I am writing to follow up your discussions of 7 June with the Urambi Body Corporate Committee and interested residents.

Mr M Fretwell President Murrumbidgee Country Club P.O. Box 816 WODEN ACT 2606

Urambi Body Corporate Committee

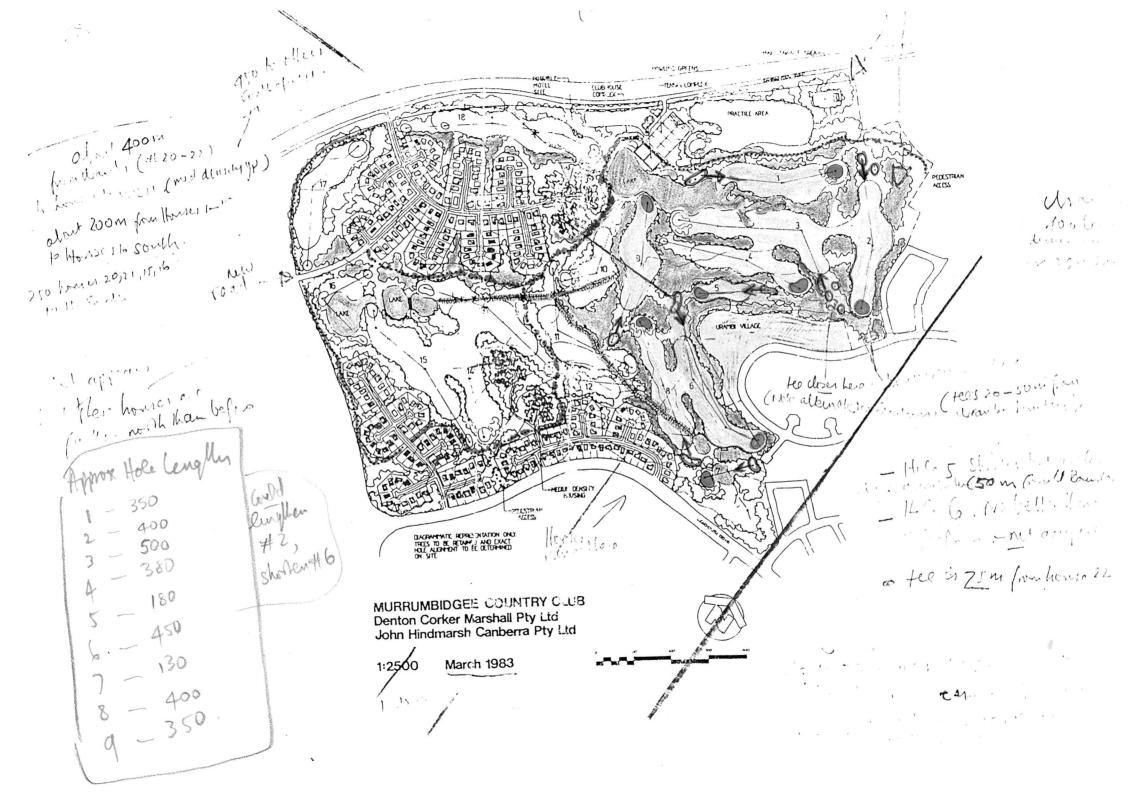
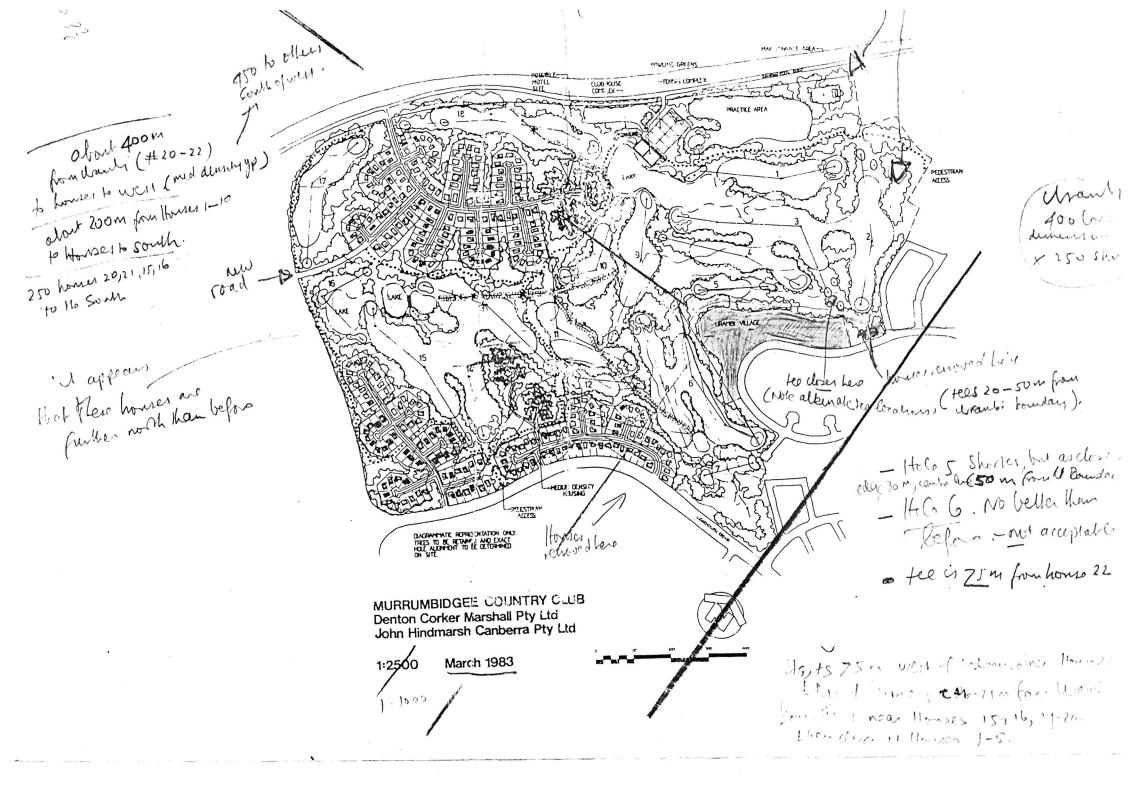
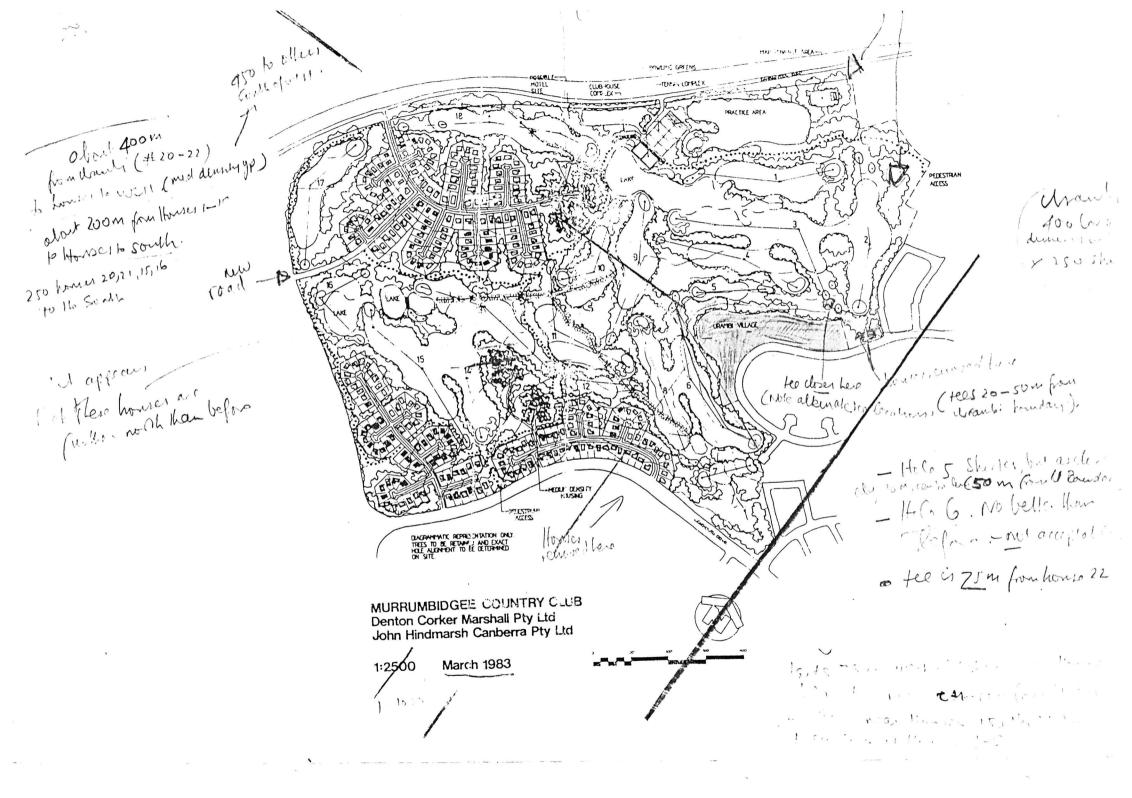
Soft course housing Excheting houses

The buffer awangement vado for wrants

(biffer stop seems about 30 metres at removers

I this correct - J so seems too rapport

Holer 5 26. reed to be absolutely sure mishits can't damage house. I which have large glain diver oneited provaids course.

Circuit goes ahead together >

is that sensite &

golf club house now not n good æsthene form Choquet now Makinises housing es much honsey to south wen of Wanter Is it a question of Good hardry community land to developer at like cost. Would westerly a holer (19-27) go to housing If course fails to go ahead suffreeenly well.
